**ATTACHMENT A**  
**PREDEVELOPMENT PLAN REVIEW COMMENTS TO APPLICANT**

## PREDEVELOPMENT PLAN REVIEW COMMENTS

**Project Number:** PPR2018-00019 **Date:** November 20, 2018

**Project Description:** Predevelopment Plan Review for the construction of a four-story, 60-unit, single-room occupancy development with 50 parking spaces.

### 15' Side Setback Abutting Residential / Encroachment Plane

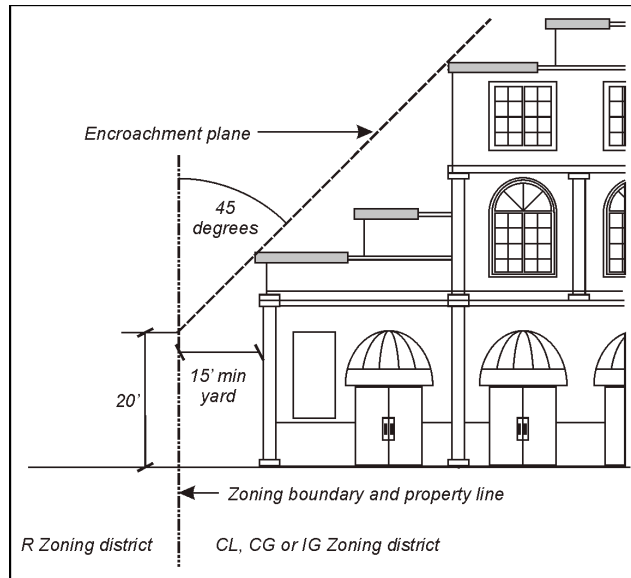
The applicant shall provide a 15-foot side setback adjacent to any abutting residential zoning district. In addition, the proposed structure shall not be located within an encroachment plane sloping upward and inward to the site at a 45-degree angle, commencing 20 feet above the existing grade at the property line of the abutting residential zoning district (Figure 4-9, 17.40.160). Projections are not permitted to encroach into the encroachment plane because the project does not use RS, RM-12 or City of Gardens standards. Both the 15-foot setback and encroachment plane standard apply along the northerly side of parcel 101 because the property abuts the RM-32 zoning district.

The first floor plan identifies a setback of five feet from the Hill Street right-of-way, but does not specify the setback at the three floors above. Therefore, compliance is unknown. Along Holliston Avenue, portions of the building provide no setback (built to the property line), with other portions setback five feet. This scenario does not comply with the setback requirement. However, a building proposed as an infill project may be allowed no setback (applies to front only) through the Design Review process if the review authority determines that a reduced front setback would allow the proposed structure to match the established building placement pattern of the block. Any setback exception requested requires the applicant to provide detailed information substantiating applicability as part of the Design Review application. This information and/or narrative shall address each component that seeks a setback exception. Be advised, where an exception is not specifically granted, a five-foot setback would apply across the frontage, necessitating project changes. The project proposes an interior side setback between 0'-6' at the north and south property lines that abut nonresidential zoning districts, which complies. The project proposes an interior side setback between 0'-15' at the northerly property line (parcel 101) that abuts a residential zoning district (RM-32). This does not comply because portions do not maintain 15 feet of setback. The exterior walls of the structure that enclose the ground floor shall maintain a 15-foot setback, consistent with the three floors above. In addition, compliance with the encroachment plane is unknown. Plans should provide a level of detail that demonstrates compliance with setback standards at each property line. Elevations and section shall depict the property line, height of commencement, angle of plane, and side setback consistent with the figure shown above.

### Height Measurement

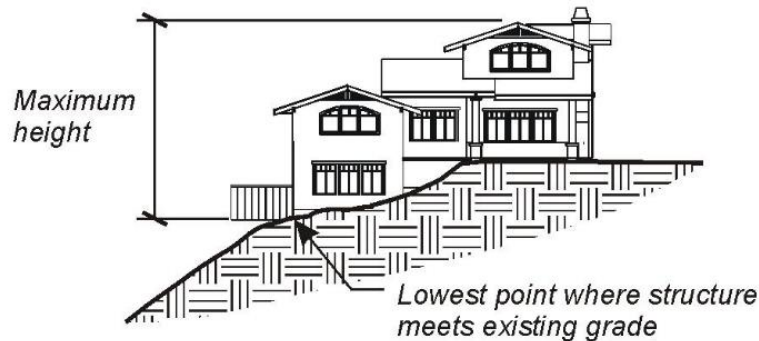
Elevation sheets reference a low point of 807.5 feet and a 45-foot dimension to the top of a parapet. The low-grade elevation appears consistent with the lowest existing grade elevation identified on the topographic survey. However, elevations sheets also suggest an element exceeds 45 feet. This element may be an elevator shaft, which qualifies as an appurtenance. Plans should provide a level of detail that demonstrates compliance with building height. Where appurtenances are proposed, plans shall identify the element, the height above the 45-foot maximum, and the percentage of the roof area occupied by all appurtenances.

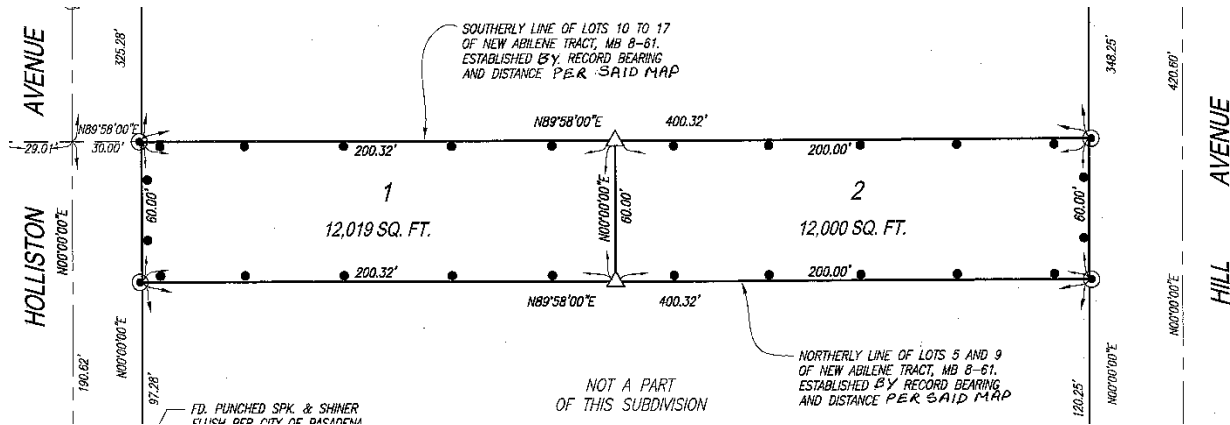
Based on a lot size of 24,000 square feet (per plan), the property is limited to a maximum gross floor area of 19,200 square feet (24,000 x 0.8) for the purpose of FAR. Be advised, Lot 1 and 2 of Parcel Map No. 60412 equates to an aggregate lot size of 24,019 square feet based on recorded lot dimensions. Please address, where necessary.

The application references a total gross of 40,200 square feet where the plan references 17,430 square feet. As a result, compliance with FAR is unknown. The applicant shall provide a dimensioned exhibit identifying all areas counted towards FAR by floor as part of any discretionary application and/or plan check submittal to verify compliance with this standard. A sample exhibit is available upon request. Be advised, the first floor gross shall include enclosed electrical/mechanical rooms, elevators, stairs, storage, lobbies, EMR, and trash (if trash is floor to ceiling) among other space not used exclusively for vehicle parking or loading.
